## CITY OF ALBUQUERQUE

1400 San Mateo Building 1400 San Mateo Blvd SE Traffic Circulation Layout

Architect's Stamp dated 11-02-16 (L18D081)

Re: 1400 San Mateo Building

1400 SAN MATEO BUILDING

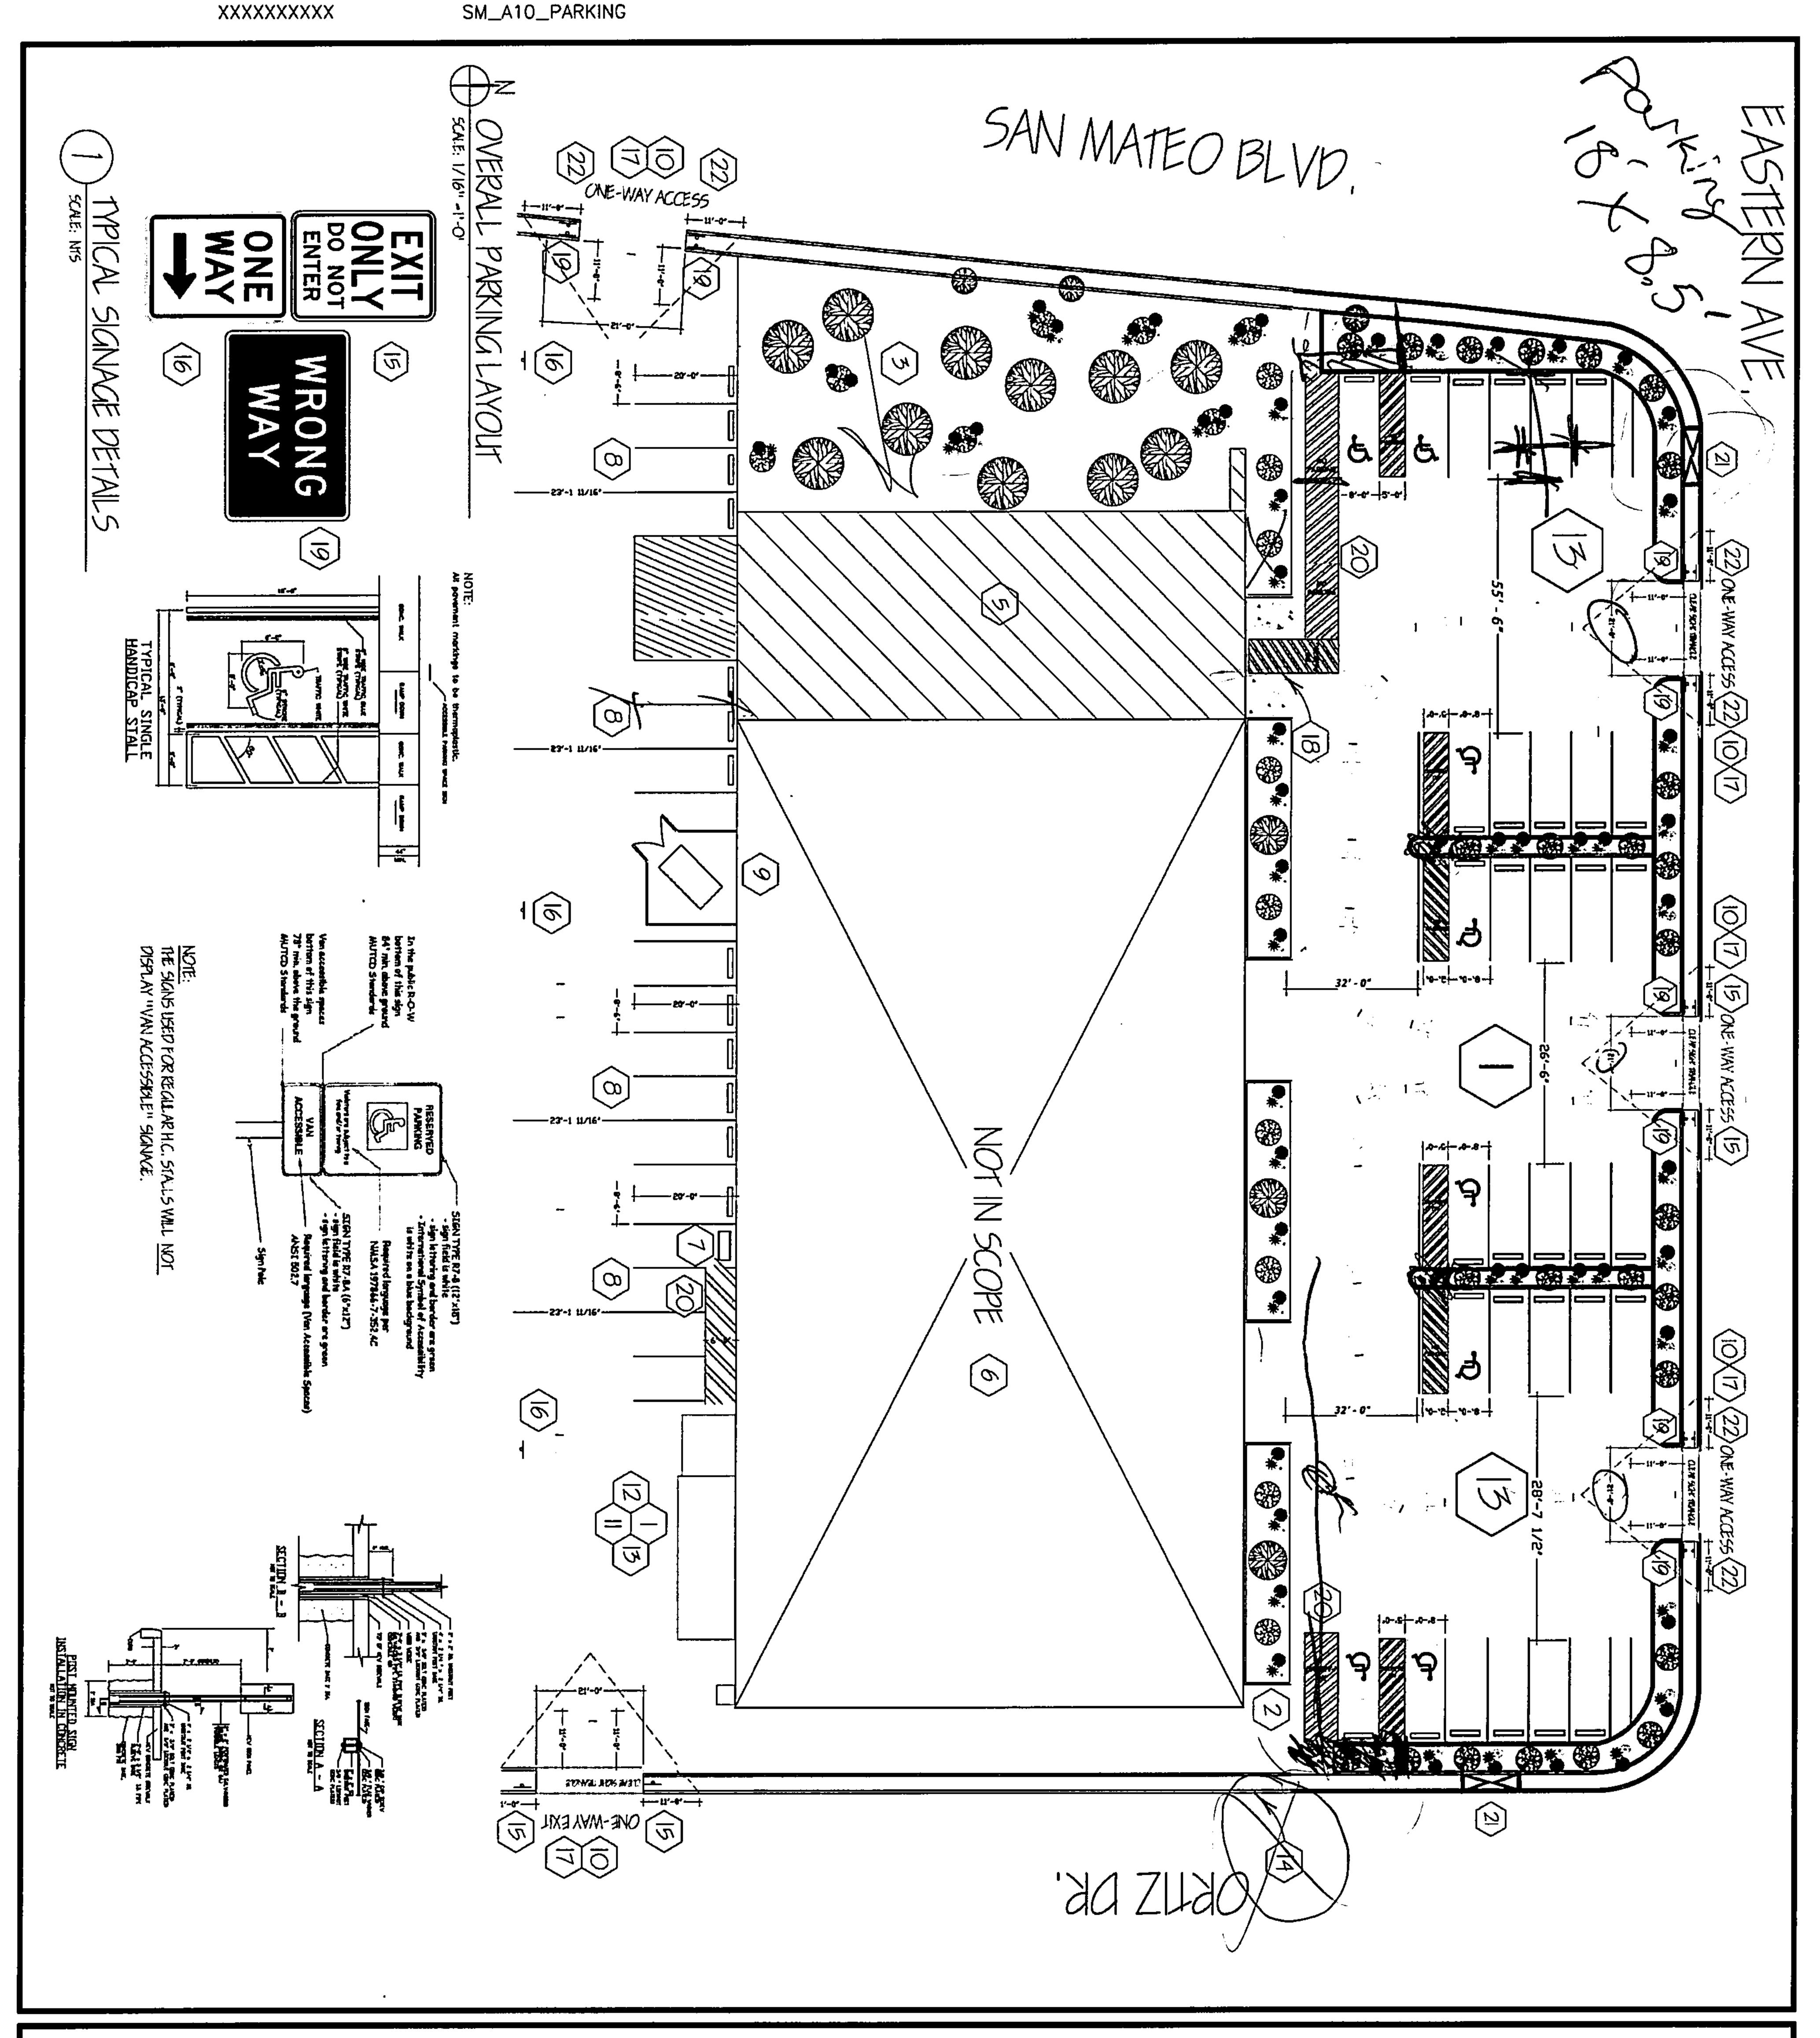
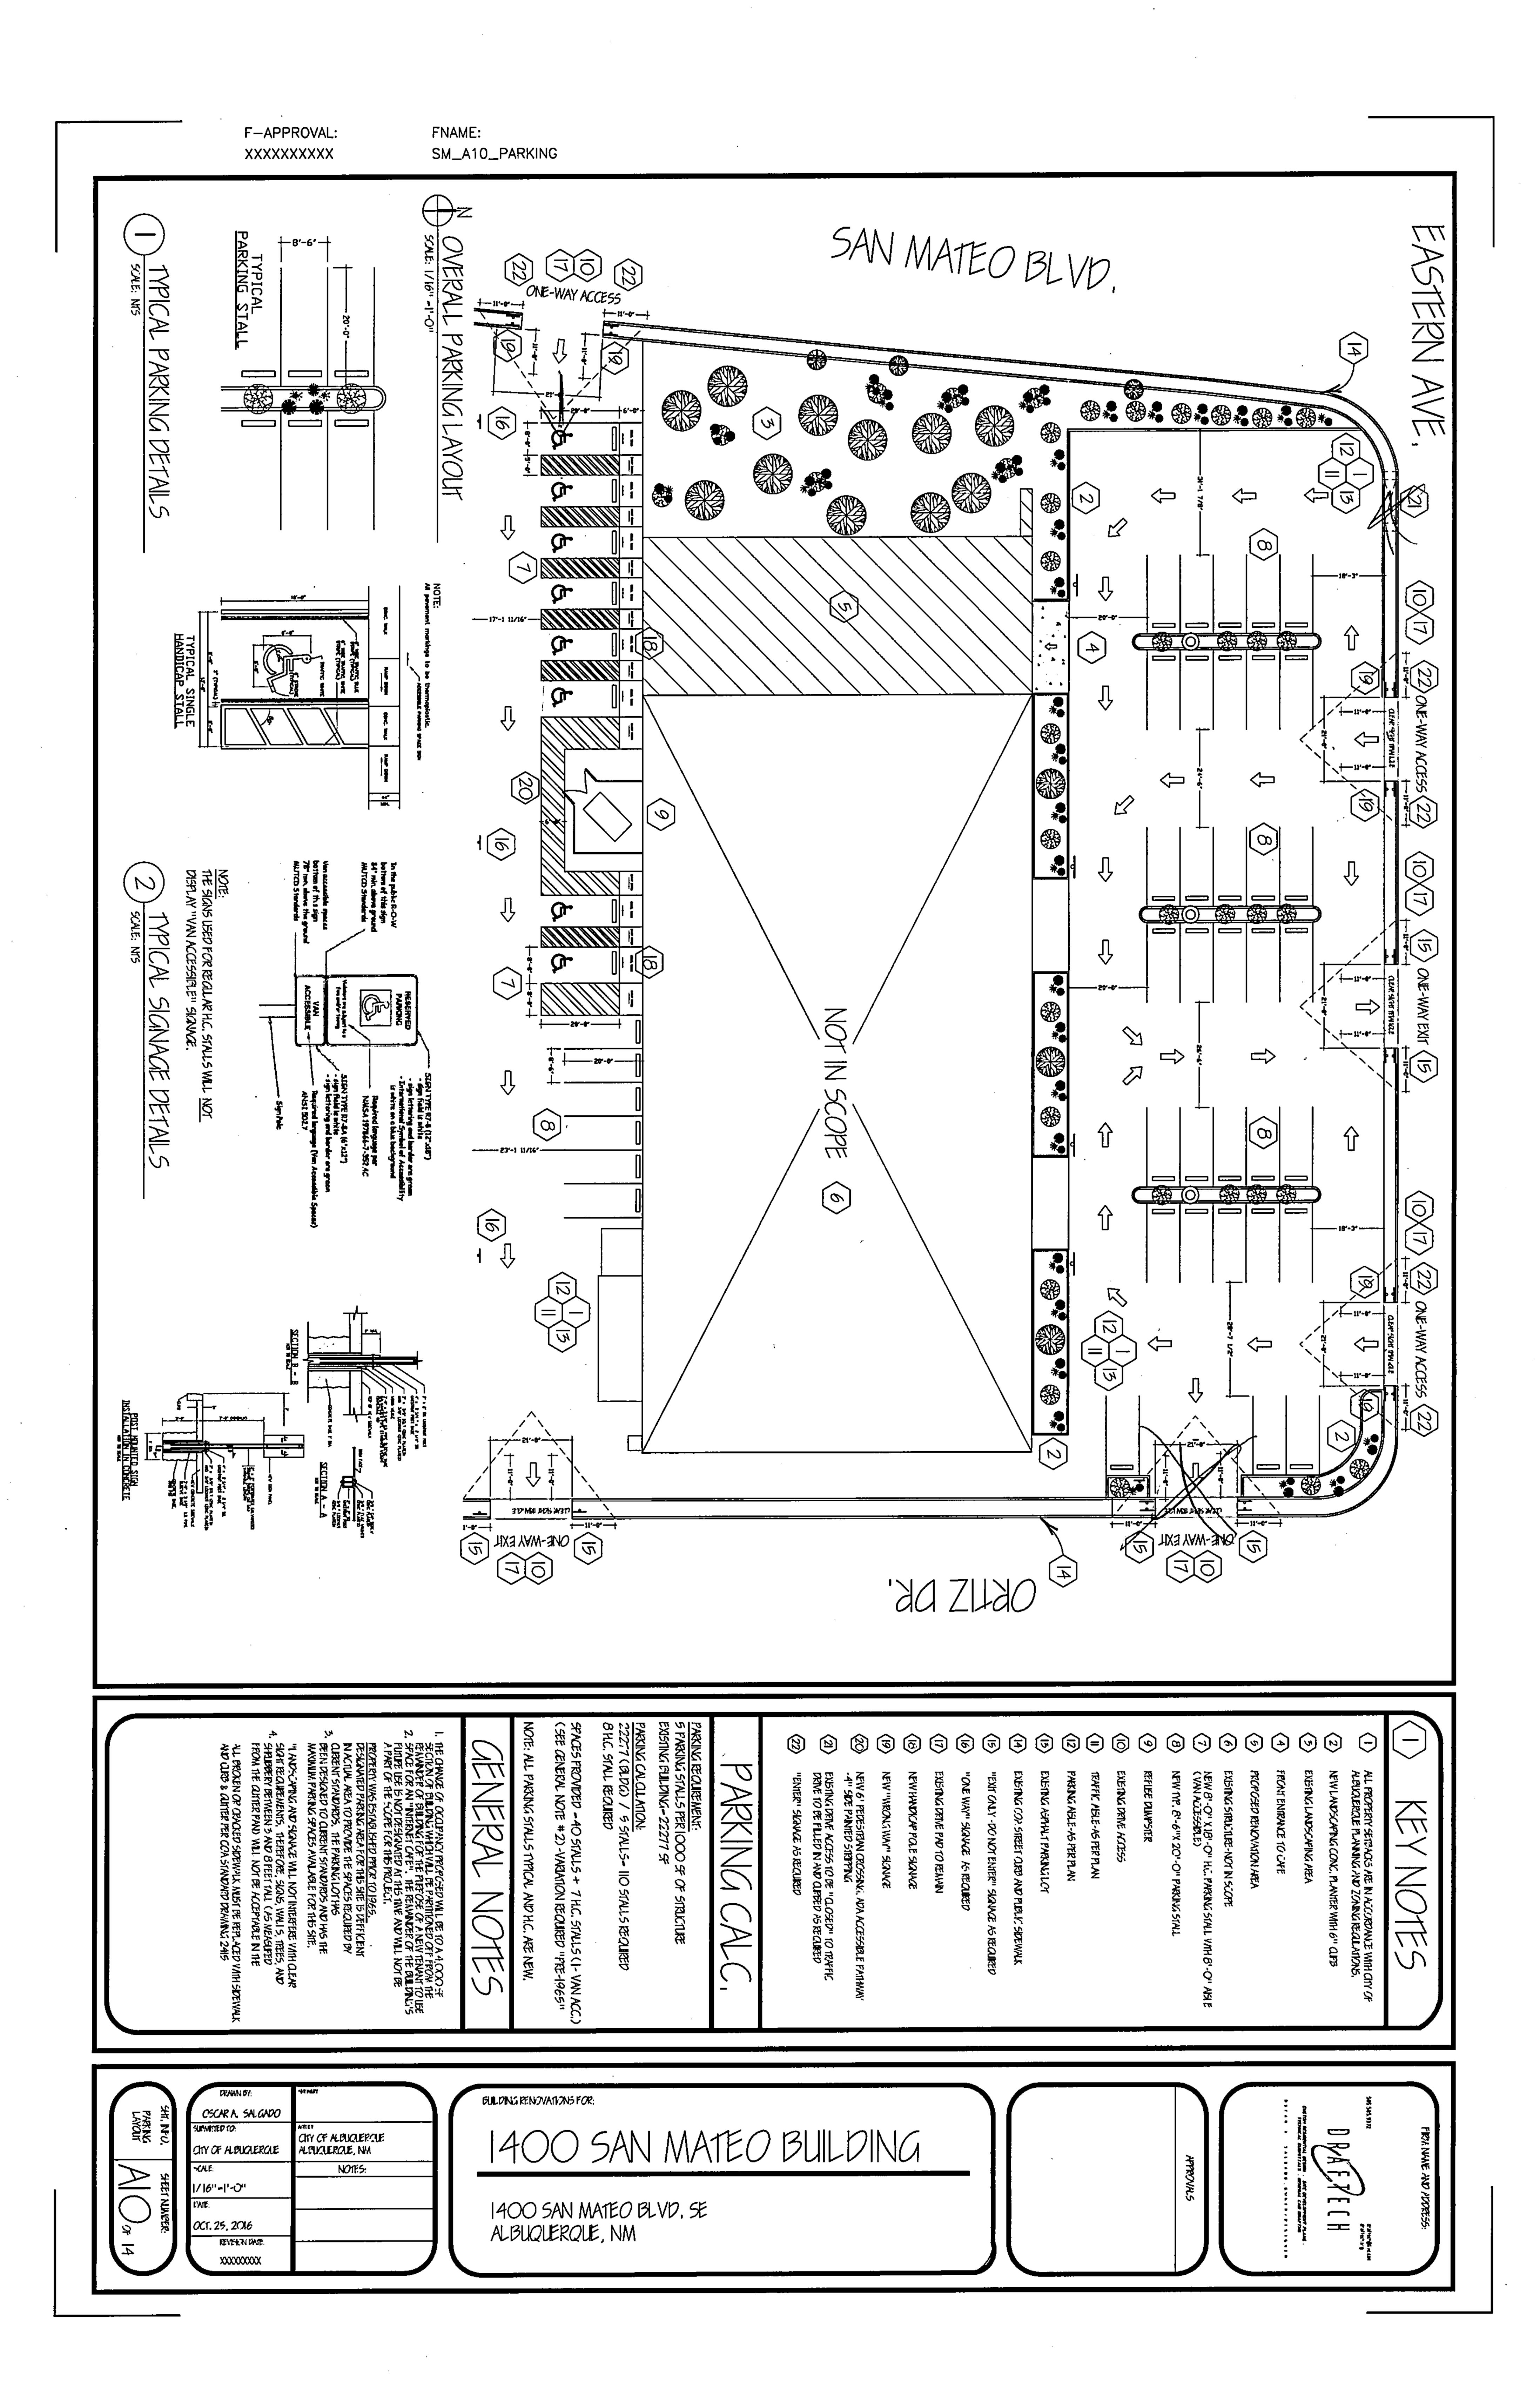
Based upon the information provided in your submittal received 09-23-16, the above referenced plan cannot be approved for Building Permit until the following comments are addressed:

- 1. Please review and revise plan to provide all information listed on the attached Traffic Circulation Layout checklist.
- 2. Please refer to the attached Accessible Parking Checklist and revise the plan accordingly.

Per the zoning code, a 6 ft. wide ADA accessible pedestrian pathway is required from the public sidewalk to the building entrances. Please clearly show this pathway and provide details.

Minimum drive access drive aisle width must be a minimum of 24 feet for two way traffic. Any width less than 24 feet must be one-way access only.

One-way vehicular paths require pavement directional signage and a posted "Do Not Enter" sign at the point of egress. Please show detail and location of posted signs.

Call out all existing and proposed access drives. Please identify any existing access drives that will be modified. Unused curb cuts must be replaced with sidewalk and curb & gutter. A build note must be provided referring to the appropriate City Standard drawing.

- 8. Please provide a sight distance exhibit
- 9. Show the clear sight triangle and add the following note to the plan: "Landscaping and signage will not interfere with clear sight requirements. Therefore, signs, walls, trees, and shrubbery between 3 and 8 feet tall (as measured from the gutter pan) will not be acceptable in the clear sight triangle.
- 10. Please specify the City Standard Drawing Number when applicable.

- 11. Add a note stating "All broken or cracked sidewalk must be replaced with sidewalk and curb & gutter." A build note must be provided referring to the appropriate City Standard drawing.
- 12. Please include two copies and a PDF copy of the traffic circulation layout at the next submittal.
